Access Design Assessment Report

28-32 Somerset Street
Kingswood NSW 2747

Project: 28-32 Somerset Street, Kingswood NSW 2747
Document Type: Access Design Assessment Report
Our Reference: P220_430-3 (ACCESS) FMR

Figure 1 – Accessible SOUs (Ground Floor)

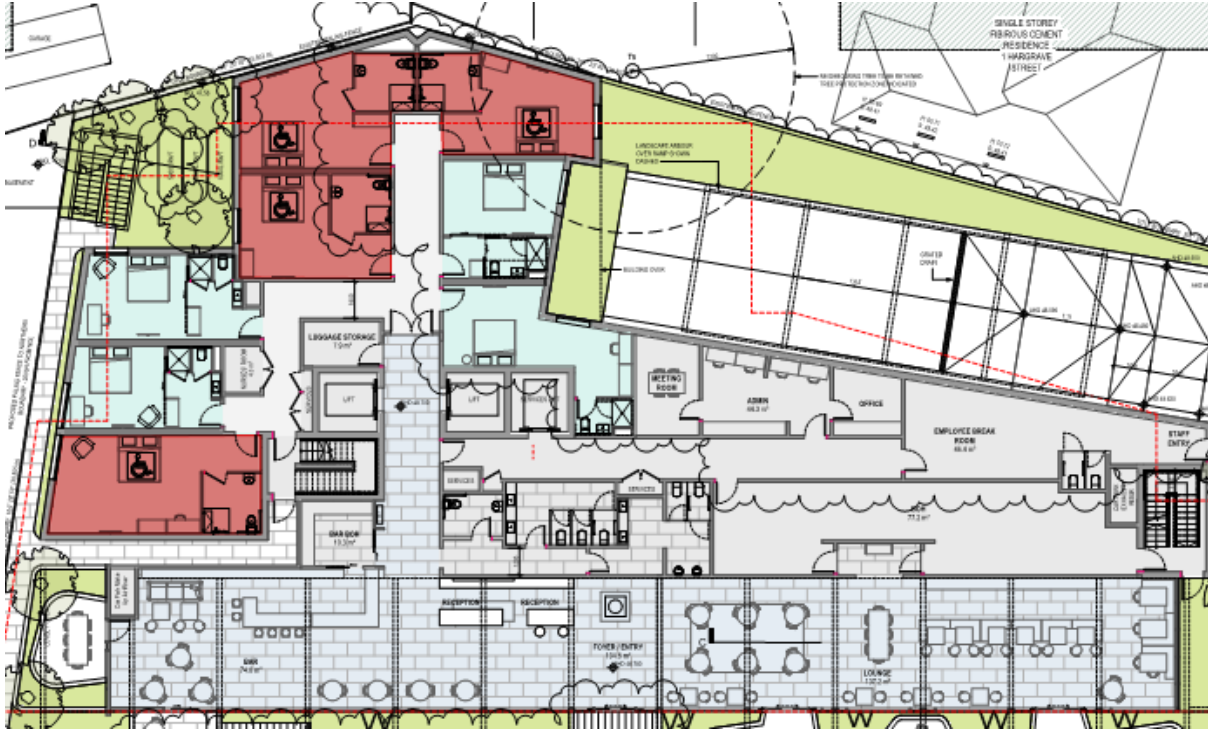
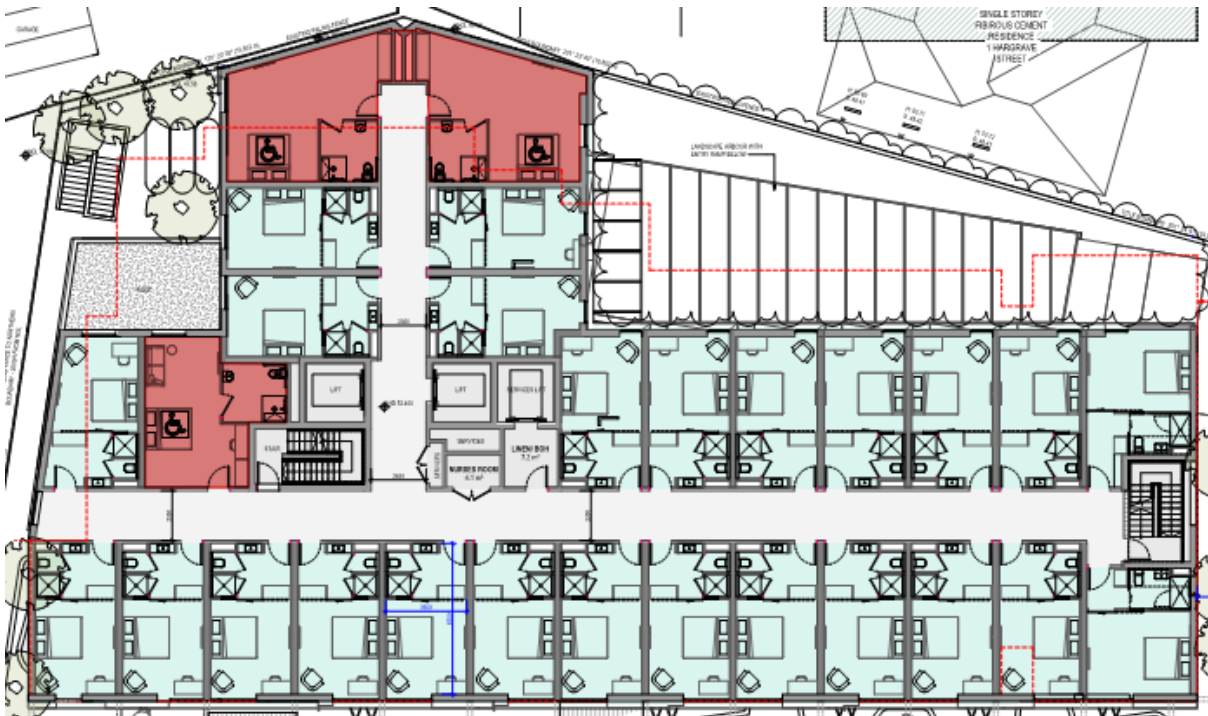
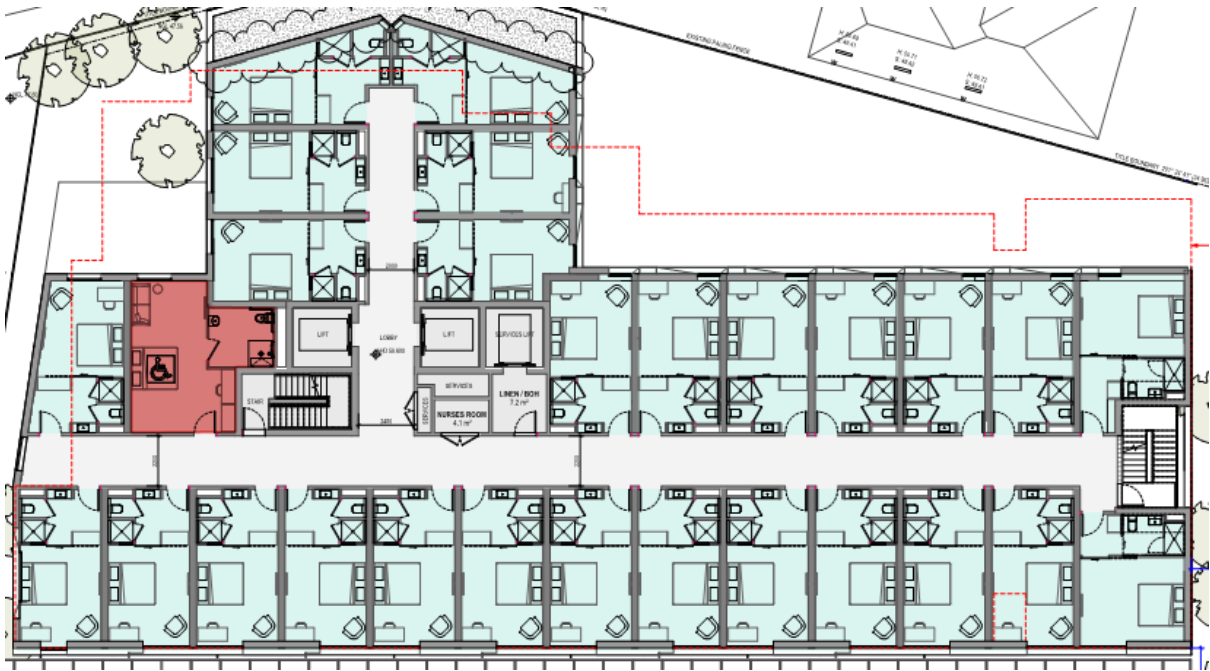
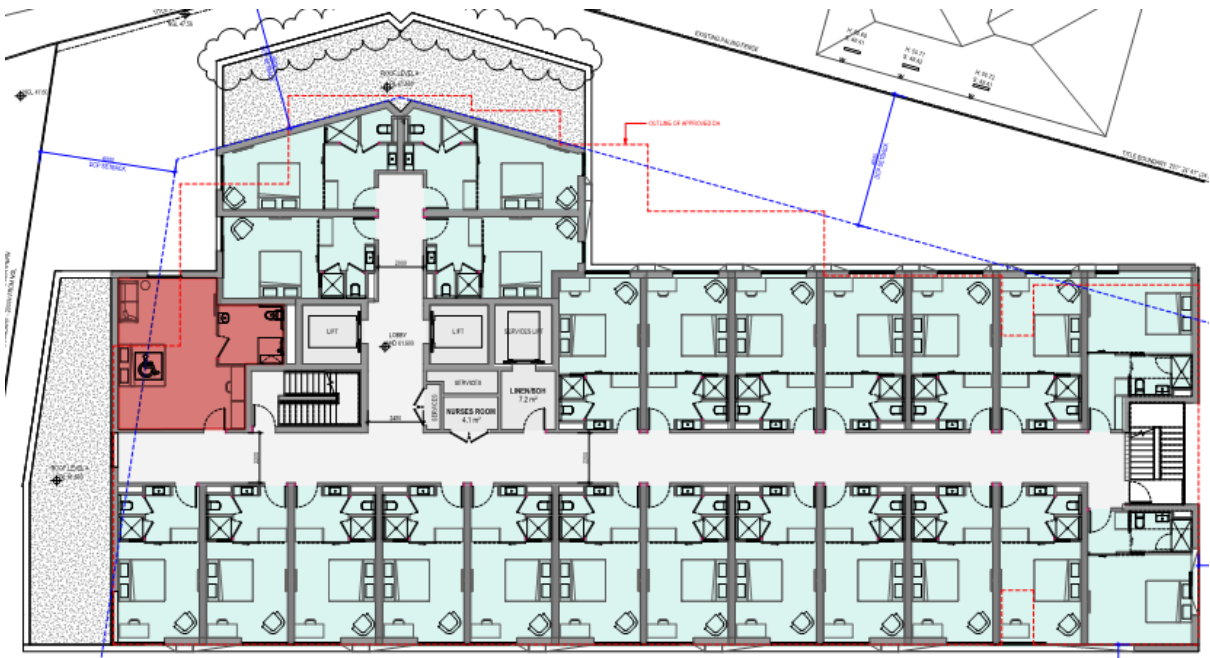
DESCRIPTION	ISSUE	COMMENT/S
Doors - clear opening widths	Generally, several doors are identified as having reduced clear opening width.	<p>Doors along the accessible path of travel are required to achieve a minimum 850mm clear opening width.</p> <p>Generally, a 920mm door leaf is required to achieve 850mm clear opening. Where double doors are used, at least the active leaf is required to achieve a minimum 850mm clear opening.</p> <p>Compliance readily achievable at the Construction Certificate documentation phase.</p>
Doors - circulation space	Generally, several doors are proposed with reduced circulation spaces.	<p>Doors along the accessible path of travel are required to be provided with circulation spaces in accordance with Clause 13.3 of AS1428.1-2009.</p> <p>Compliance readily achievable at the Construction Certificate documentation phase.</p>
Location of accessible SOUs	It is noted that more than 2 sole occupancy units are located adjacent to each other on the ground floor, being 3, and are not representative of the range of rooms available.	<p>It is noted that of the rooms available are similar in layout and feature and hence it is recommended that not more than 2 accessible sole occupancy units be located adjacent to one another.</p> <p>Alternatively, the proposed layout comprising 3 accessible SOUs located adjacent to one another may be justified via a performance-based solution.</p>

Figure 4 – Pedestrian Entries

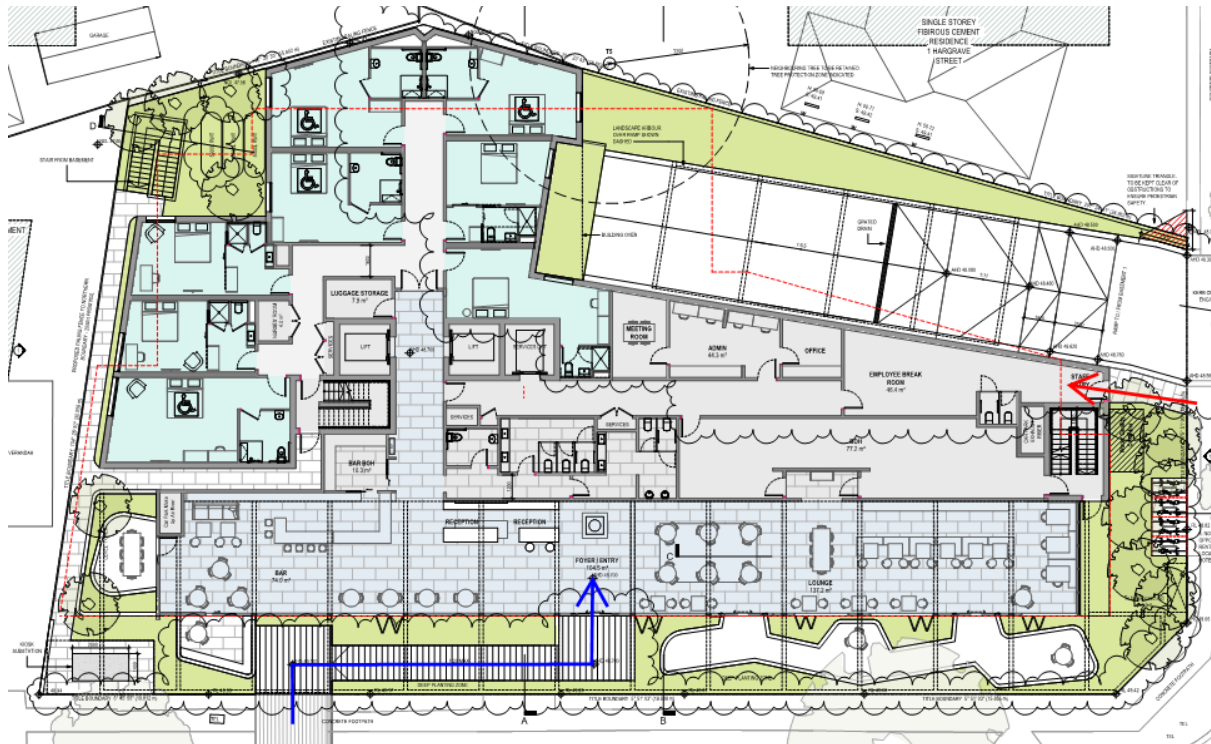
DESCRIPTION	COMMENT/S
Accessway from the site boundary	<p>The proposed levels at the allotment boundary to the building entrances are noted as being adequate to facilitate access to the building.</p> <p>Ensure an accessway is provided from the site boundary to the entry doors.</p> <p>As design progresses, provide further details for assessment.</p>
